ACCESS COMPLIANCE ASSESSMENT REPORT

ST MARY ST JOSEPH CATHOLIC PRIMARY SCHOOL
280 FITZGERALD AVENUE MAROUBRA NSW 2035

REPORT NO. ► PROJECT 9549 - REV 3.0

Zone B – Ground floor

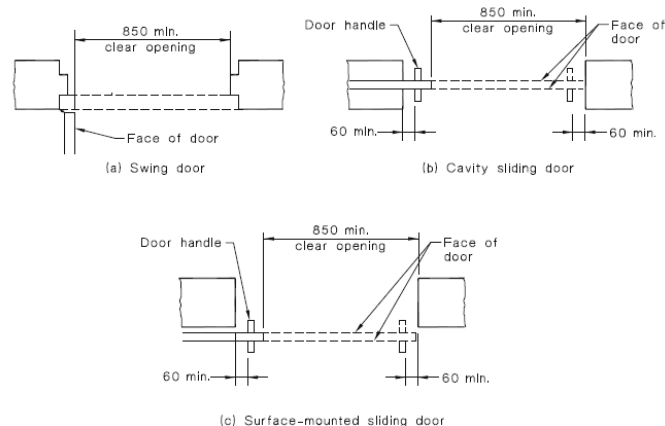
- Plans identifies doorways throughout the ground floor maintaining less than 850mm openings (circa 705mm). A doorway shall be 850mm when measured from the face of the opened door to the doorstop. Refer to figure 30 below for clear openings of doorways. All doors are to be reviewed to ensure 850mm opening exists.

- Bi-fold doorways to ART room are not an acceptable doorway under AS1428.1-2009 and it is suggested that these doors are reviewed prior to CC stage.

Zone B – Ground floor

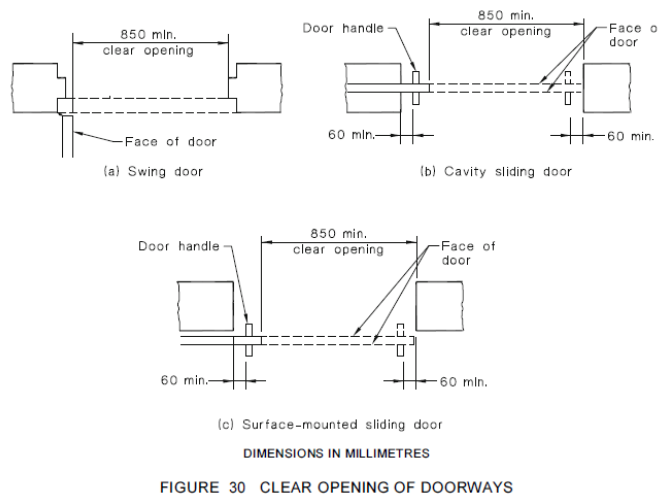
- Plans notate double doors (existing and proposed) with a single leaf door maintain a clear opening of 850mm (circa 635mm – worst case scenario). Double doors on a continuous accessible path of travel must maintain one leaf (active leaf) width of 850mm in accordance with Clause 13.2 of AS1428.1-2009. Refer to figure 30 below for clear openings of doorways.
